Subject : Inspection of aileron weight and aileron c.g. and inspection of play (backlash) in aileron and flap control circuits to avoid flutter risk.

Effectivity : Glider model ASW 20, s/n 20 001 thru 20077 and 20 086.

ASW 20
Technical Note
No.12

Alexander Schleicher
Segelflugzeugbau
6416 Poppenhausen

Determination of tailheavy moment of controls by balancing on a cutting edge done twice (triangular strip)

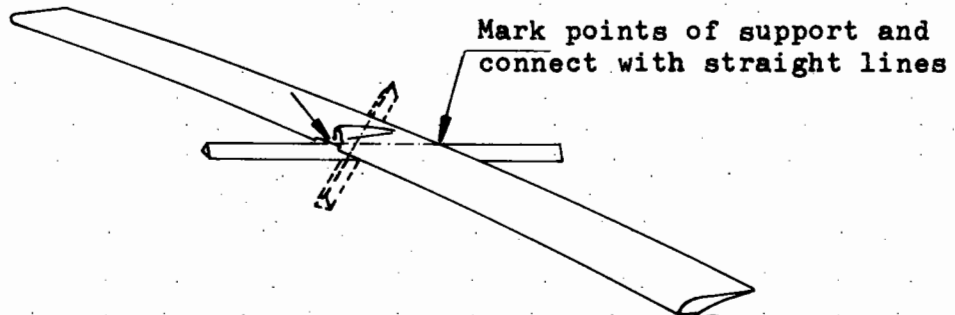
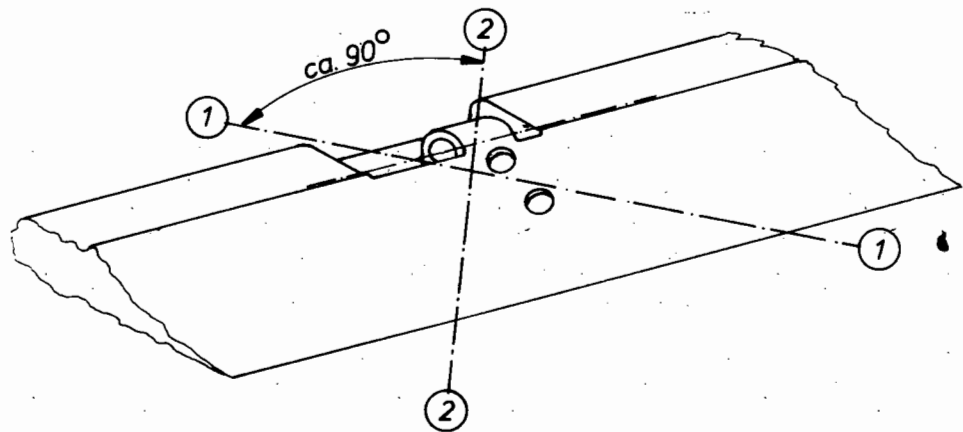
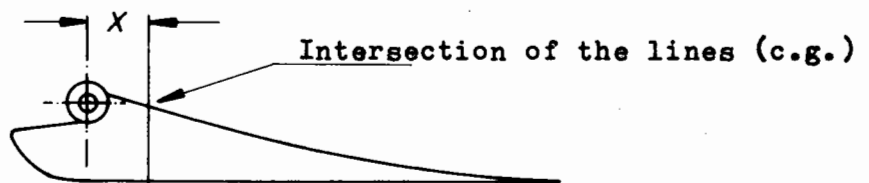
Diverging from the sketch in the Manuals the c.g. of the ailerons is balanced according to the sketch on sheet 5 of this Technical Note. The weight of the aileron (if fittings have been removed, without their 0.07 kg) as determined multiplied by the distance from the c.g. to the hingeline is the tailheavy moment of the aileron. If the actuator fitting was removed, 0.15cmkg must be added. This total moment must not be greater than tolerated by the Manuals.

The connecting lines of the points of support ① - ① and ② - ② intersect in the c.g.

X = Distance from the c.g. to the center of the hingeline.

Weight (kg) · X (cm) = Moment (cmkg)
